POWER BOARD Change Part

Change list

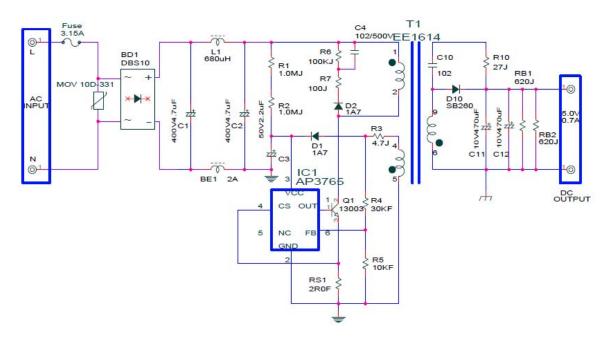
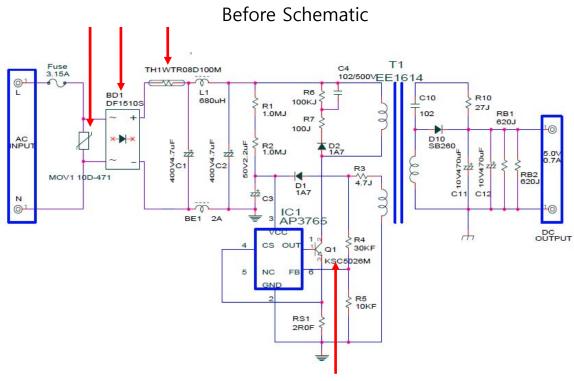
Item	before	after	비고
Varistor	10D331	10D471	Value change
Bridge Diode	DBS10	DF1510S	Part change
Thermisitor	-	WTR08D100M	Circuit add
Transistor	APT13003EZ(EU)TR-G1	KSC5026M	Part change
